**Veolia Environmental Services Pty Ltd  
Woodlawn Bioreactor (SSD MP 10\_0012)  
Independent Audit 2022  
Leachate and Water Management System**

This report presents the findings of an Independent Environmental Audit that was conducted to assess the environmental performance of Veolia Environmental Services Australia's water and leachate management system associated with the Woodlawn Bioreactor Landfill, located at Collector Rd, Tarago.

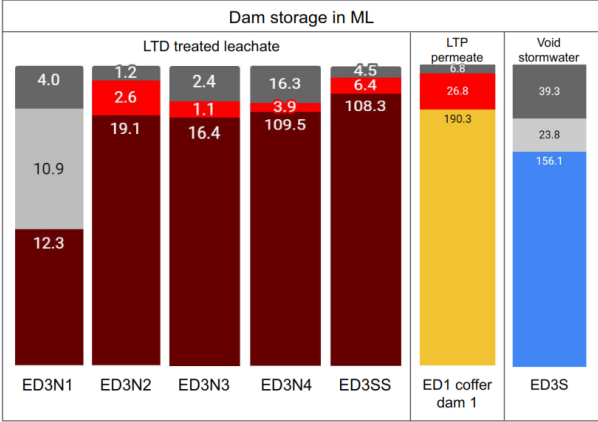
| Conditions of Development Consent – MP10_0012 (Consolidated consent including Mods 1, 2, 3 and 4) |  |   |   |                            |                                      |
|---|--|---|---|----------------------------|--------------------------------------|
| 18R(b)(i)   | Assess actual performance against the assumptions and  | Dam monthly storage levels,   | <b>Findings:</b><br>+ Inputs and outputs from each dam consists of direct rainfall and leachate pumped into the   | Non-compliant <sup>1</sup> | NC1(a)                               |

| Consent Condition | Requirement | Evidence Collected | Independent Audit Findings and Recommendations   | Compliance Status | Unique Identification Non-compliance |
|-------------------|-------------|--------------------|--|-------------------|--------------------------------------|
|                   |             |                    | <p>existing water balance model.</p> <p>+ In response, it is understood that Veolia has sought proposals from independent experts to prepare the strategy as required under the Development Control Order.</p> <p><b>Recommendations:</b></p> <p>+ The leachate and water management strategy as required under April 2022 Development Control Order be completed in 2022 as a priority, including a revised water balance model, with a development modification submitted to DPE seeking to implement the required changes to the water management system. This modification shall also seek to update the reference water balance model for future compliance assessments.</p> <p>+ The development modification shall also include a revised and practical target date(s) for emptying of ED3N lagoons and replace their liners based on an updated water balance model.</p> <p>+ When conducting a revised water balance consider constructability impacts of wet periods and the additional time required to allow ground conditions to enable work to commence.</p> <p>+ When revising the water balance, validate the water balance for both wet and dry years.</p> <p>+ When revising the water balance validate the water balance. This means comparing predicted storage levels and volumes against recorded storage volumes using historical rainfall. While this process was described by WSP, no evidence of it being undertaken was included in any of the water balance reports. If the validation proves a reasonably good fit between predicted and observed storage volumes then it would result in confidence in the model.</p> <p>+ If using Goldsim to revise the water balance, Veolia should obtain a Goldsim player model which enables multiple and in-depth sensitivity analysis to be undertaken. It should have as many factors/variables accessible for change by Veolia as possible including climate change factors or multipliers which would allow rainfall depths to be multiplied and evaporation to also be multiplied.</p> <p>+ Obtain all water balance models and data from the consultant that prepares the water balance and make this a condition of engagement.</p> <p>One the revised water balance is prepared:</p> <p>+ Determine the conditions under which the leachate storage dams will overflow without any additional preventative emergency action.</p> <p>+ If it is found that there is a range of conditions under which this may occur, define trigger levels to establish if these conditions are likely to occur and develop an approved contingency plan to manage this and minimise the impact of any preventative measures.</p> <p>+ If the contingency plan identifies the need for measures to create additional storage on</p> |                   |                                      |

| Consent Condition | Requirement   | Evidence Collected                          | Independent Audit Findings and Recommendations   | Compliance Status | Unique Identification Non-compliance |
|-------------------|---|---|--|-------------------|--------------------------------------|
|                   |   |   | <p>the site, establish if it's feasible to rapidly treat mechanically, or otherwise, any of the acid mine drainage (AMD) water stored on the site to create additional storage space for leachate. This might see AMD water neutralised and stripped of harmful metals or chemicals prior to on site disposal via irrigation.</p> <ul style="list-style-type: none"> <li>+ Seek all relevant approvals for the contingency plan to be executed.</li> <li>+ Regardless of any ongoing wet weather event, assess the viability of mechanical or other forms of treatment of AMD water on site and determine if evaporation is the best method for emptying storage dams which contain AMD water.</li> <li>+ Revise the timeframe for emptying of the ED1 and ED3 dams for a range of potential conditions and ensure the water balance considers the fate of water that may need to be pumped out of one storage and into another and explain how this affects the ability to deliver the strategy under various climatic conditions.</li> <li>+ Consider how the continued operation of the LTD and need to store leachate that has passed through the LTD so that it can dilute LTP influent will impact on the time to dewater all the ED3N lagoons and install a liner in them.</li> <li>+ Reassess if a third additional coffer dam is likely to be needed and if so, seek approval to commence construction.</li> <li>+ Revisit the strategy to dispose of all ED3N leachate by evaporation and determine if its viable to safely irrigate any treated leachate on the site. If viable, this would establish protocols for irrigation driven by the need to ensure that runoff containing leachate does not leave the site and enter the drinking water catchments.</li> <li>+ Factor in realistic delays to construction programme from wet weather and disruption to supply chains or operations caused by COVID.</li> <li>+ Ensure that water balance results are meaningful – for example ensure that the predicted time to empty one storage does not overlap with the predicted time to fill an alternative storage such as making sure ED3N dams can be emptied prior to ED1 Cofferd Dam being fill and spilling under a range of scenarios and then working out how long it may take to empty under a range of subsequent conditions.</li> <li>+ Both the revised site water balance and revised management strategies should be subject to a comprehensive peer review. The peer reviewer should be involved from the commencement of the work and shall inform and agree to the scope of works, water balance methodology, final water balance model and any recommendations.</li> </ul> |                   |                                      |

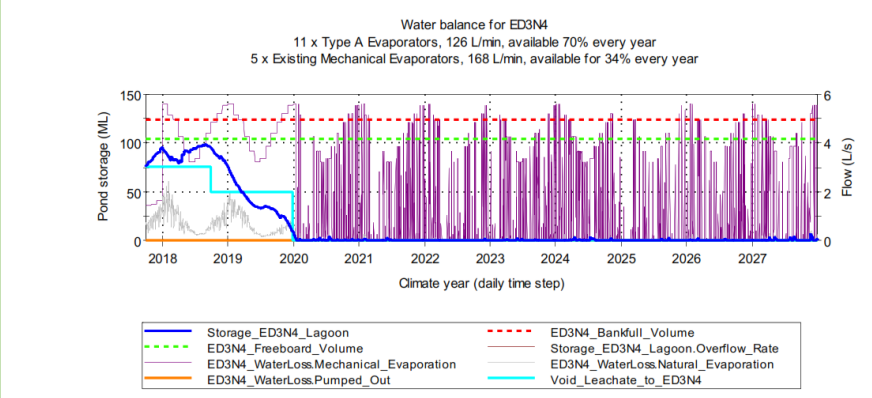
| Consent Condition | Requirement   | Evidence Collected                          | Independent Audit Findings and Recommendations   | Compliance Status | Unique Identification Non-compliance |
|-------------------|---|---|--|-------------------|--------------------------------------|
| 18R(b)(ii)        | Assess actual performance against the assumptions and predictions made in the project water balance | Actual mechanical evaporation from each dam | <p><b>Findings:</b></p> <ul style="list-style-type: none"> <li>+ Actual versus predicted mechanical evaporation from each dam is assessed under this consent condition.</li> <li>+ It is not physically possible to measure the effectiveness of mechanical evaporation except</li> </ul>  | Non-compliant     | NC1(b)                               |

| Consent Condition | Requirement  | Evidence Collected  | Independent Audit Findings and Recommendations  | Compliance Status | Unique Identification Non-compliance |
|-------------------|--|---|---|-------------------|--------------------------------------|
|                   |  |   | <p>c) Estimates must account for wind direction and how this impacts availability. Wind roses from the adjacent wind farm may be used to inform better modelling practices.</p> <p>d) Consider adopting a conservative approach on all future modelling and adopt actual wettest period mechanical evaporation.</p> <p><b>Figure A3. ED3N4 predictions under the wettest climate scenario (Extracted from the 2017 Water Balance).</b></p>  <p><b>Recommendations:</b><br/>       + The previous recommendation for NC1 will address this non-compliance.</p> |                   |                                      |
